**SERVICE BULLETIN 0612-001**  
12-10-2006, Revision IR

**SUPERCHARGER BELT COOLING TUBE**

Cessna 182 aircraft models E through R modified with Forced Aeromotive Technologies supercharger systems, STC # SA10232SC

Figure 1

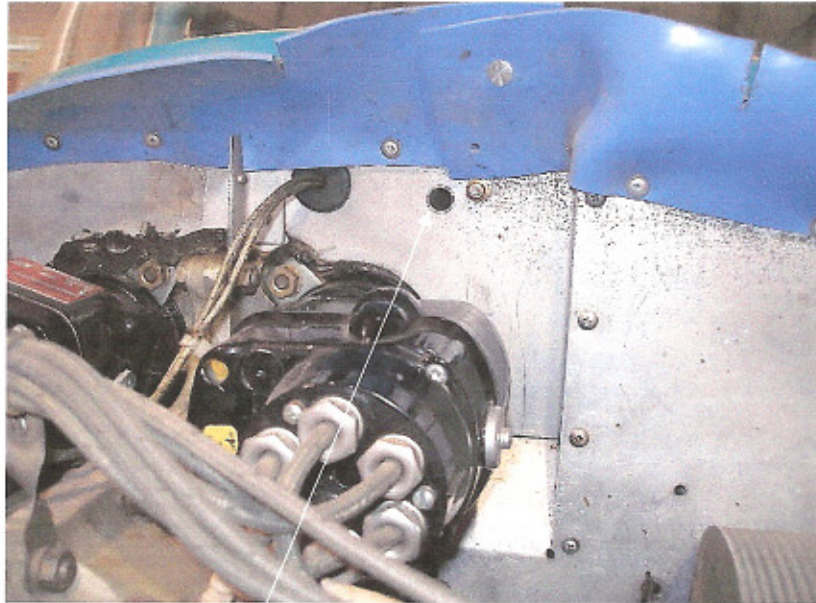
1. Drill a 0.5 inch hole in the baffle at the left edge of the crankcase and just below the baffle seal. De-burr edges and clean area using best shop practice. (Figure 1)
2. Bend a 13.0 inch length of 0.5 inch 3003-0, or 6061 aluminum tube, to approximately a 67 degree angle so it will make a smooth bend from the hole drilled in step 1 to a point 1.0 to 2.0 inches from the supercharger and alternator belts where they meet the drive pulley. Bend the tube to curve it at a point 5.0 inches aft of the engine baffle. (Figure 2)

Drill 0.5 inch hole for tube  
Bend tube here

Figure 2

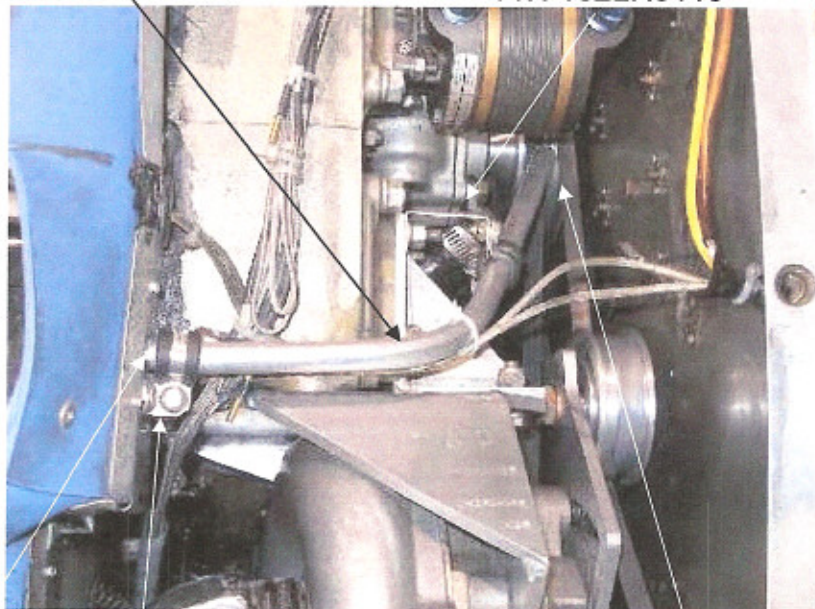
Hole through baffle  
AN743-12 bracket and MS21919-DG8 clamp

3. Insert the tube in the baffle with approximately 1/16 inch protruding forward of the baffle. Seal around the tubing using RTV. Secure the tube to the baffle using an AN743-12 bracket and MS 21919-DG8 clamp and an AN3 bolt and AN363 nut (Figure 2).
4. Secure the tube to the upper right stud on the left accessory pad using an MS21919-DG8 clamp, FAT Inc. bracket, P/N 182LR0115, and an AN3 bolt and AN363 nut (Figure 3). Ensure the tube is directed at the accessory drive pulley which drives the supercharger and alternator belts and that it terminates at a distance of 1-2 inches from the pulley.
